## SERVICE BULLETIN

**APPLICABILITY:** 2001MY and later Impreza WRX  
**SUBJECT:** Modification to Rear Brake Caliper

**NUMBER:** 06-36-06  
**DATE:** 06/23/06

Old Disk Brake Kit: 26692FE040/050 (LH/RH)

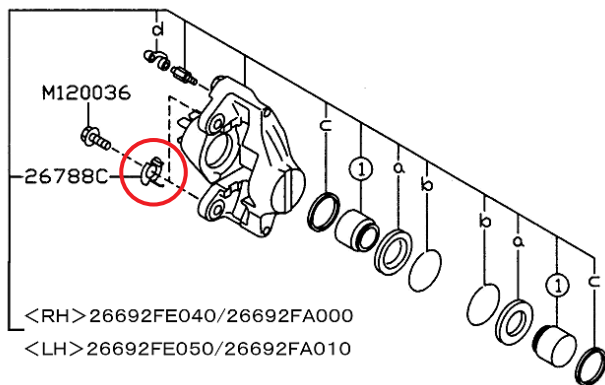
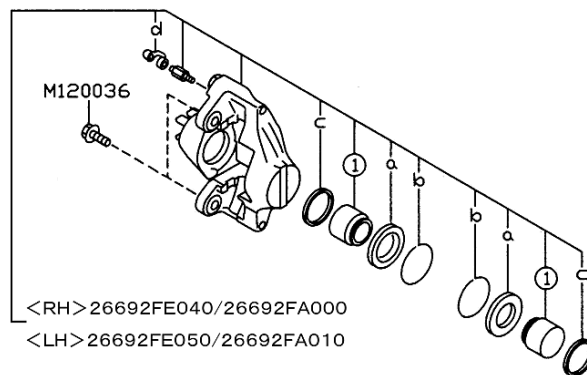
A production change was made to the rear brake caliper on 01MY and newer Impreza WRX. The washer between the caliper body and the backing plate has been discontinued. A change has been made to the caliper body to maintain the correct geometry, although the part numbers have not changed.

**Note:** Though there were design changes made to this part, the part numbers remain the same.
